From: Steve Christensen
To: John Gefferth
Date: 6/19/2007 3:26 PM
Subject: Emery Hydro Section
Attachments: Emery Deep Water Rights.pdf; Emery Deep Water Rights 2.pdf; Emery Hydro Sug
gestions.doc

**Emery Deep Mine
Near Town of Emery Utah**

Emery Deep Hydrology Section (Chapter VI):

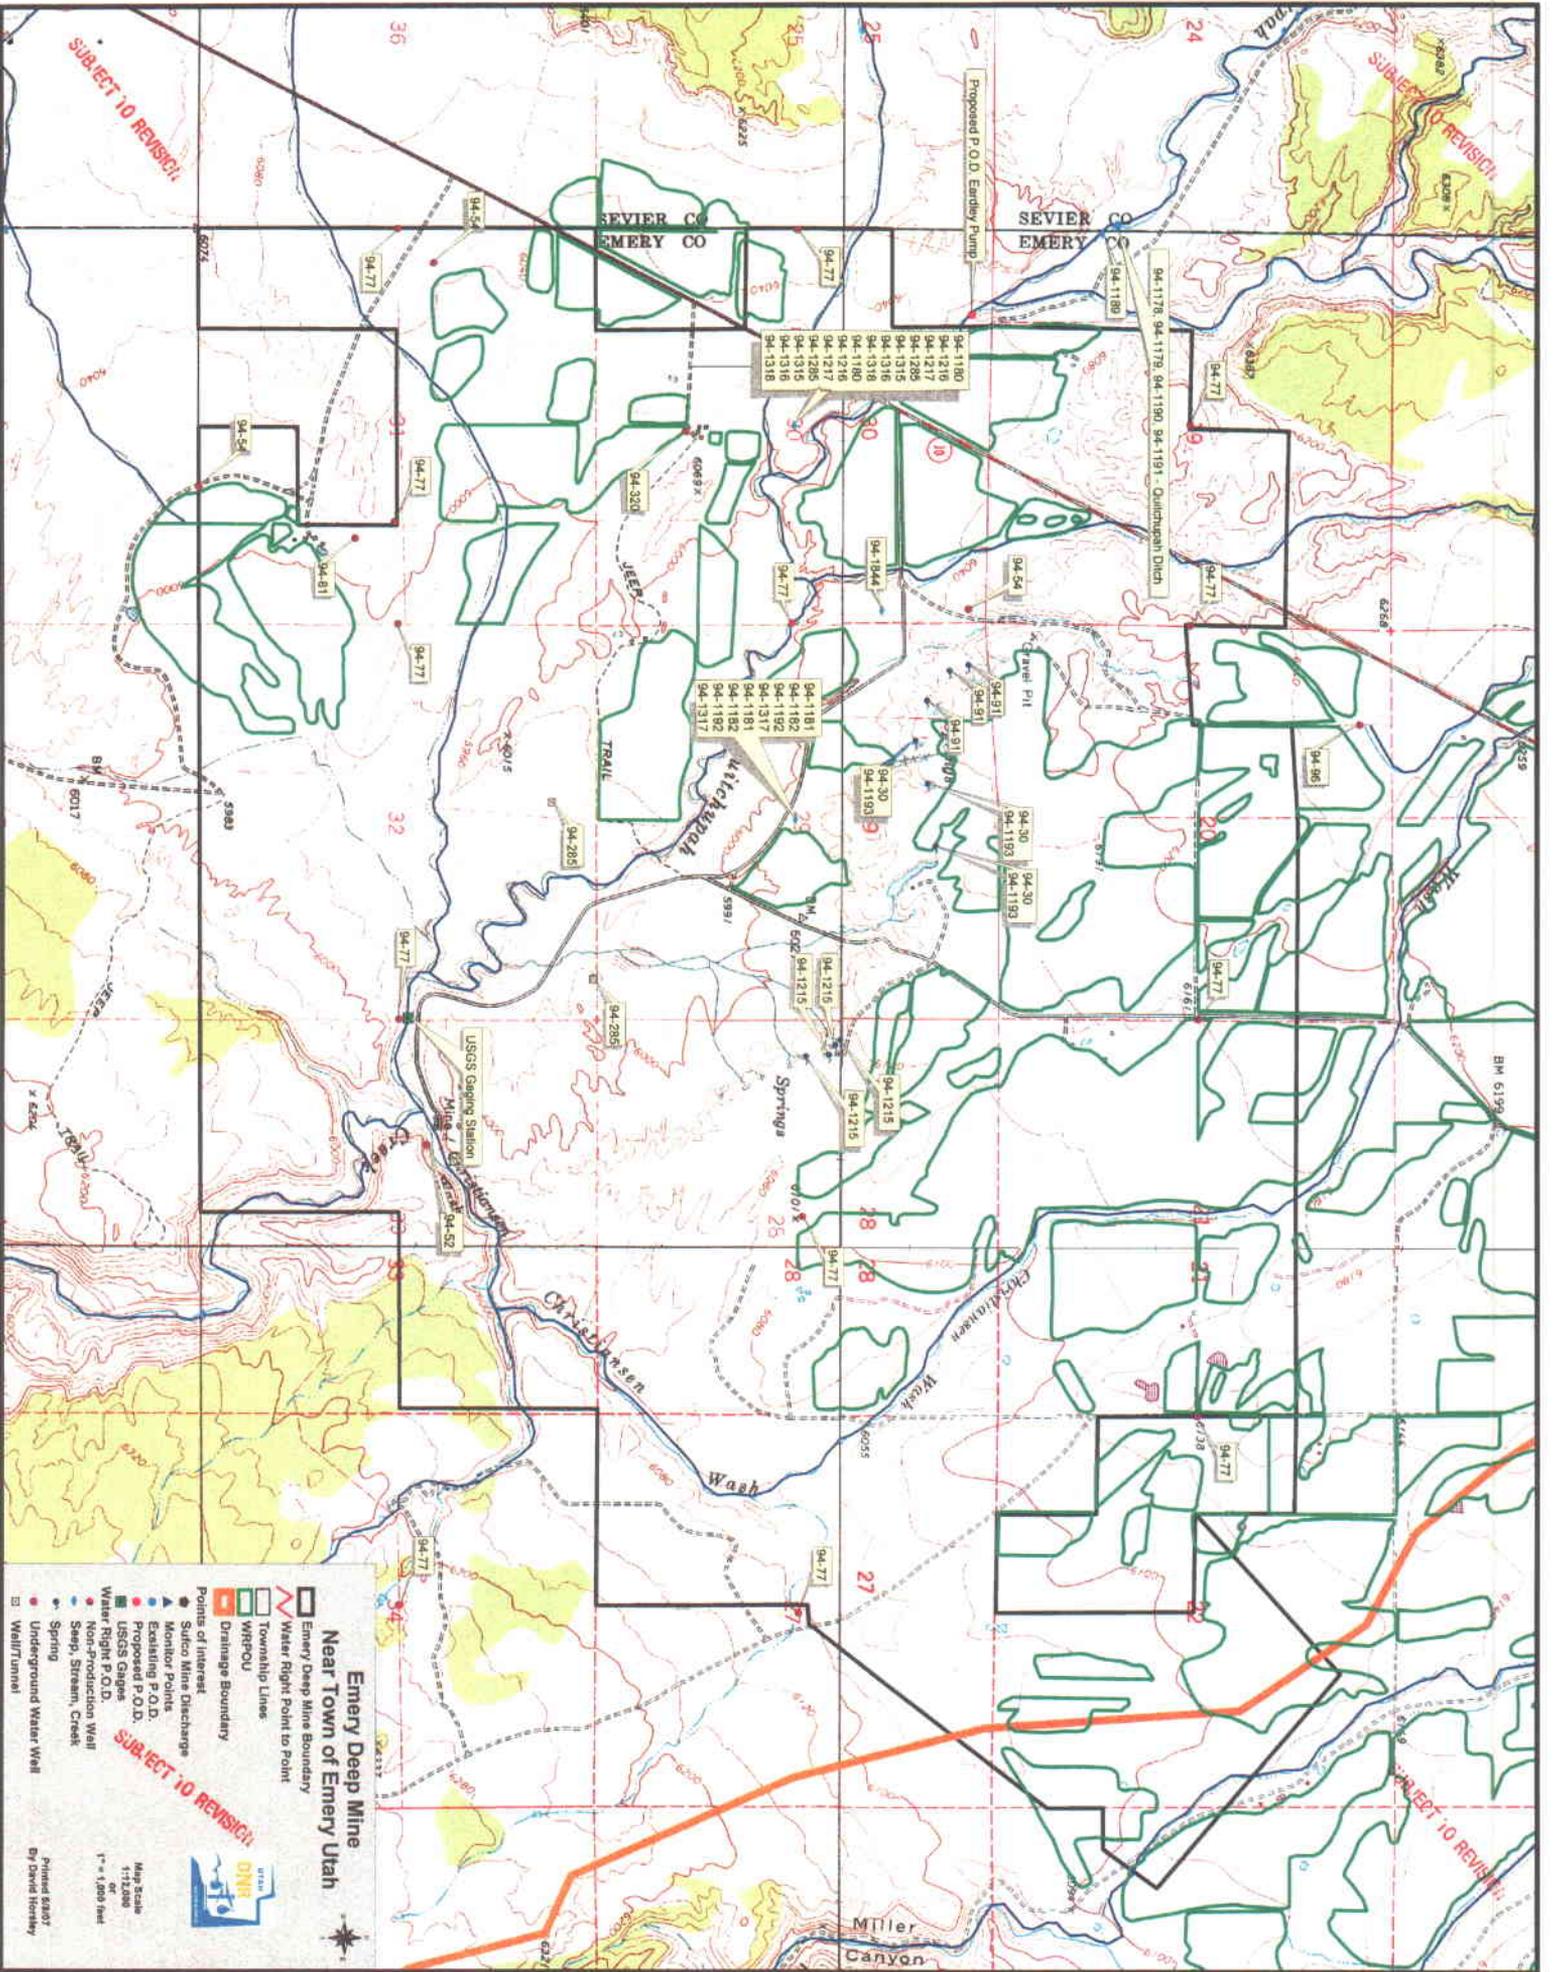
The other two files are maps that were generated by the Water Rights office in Price, UT. I asked Marc Stillson to put these together in light of the SP-10 questions that have come up recently. These are the maps that I'll be using for review purposes. Please check and see if these maps correspond with you're water right information as we'll have to reconcile any differences that emerge.

investigation, it appears that some clarification of the water rights may be needed. For example, Plate VI-6 does not depict water right no. 94-30, however it's listed in the table on page 141. The Water Rights maps I've attached depicts water right 94-30 in three locations (springs SP-10, SP-11 and SP-12). In addition, Plate VI-6 depicts the number "302" next to water right 94-1193. Upon review of the water right information, it's unclear what "302" corresponds to.
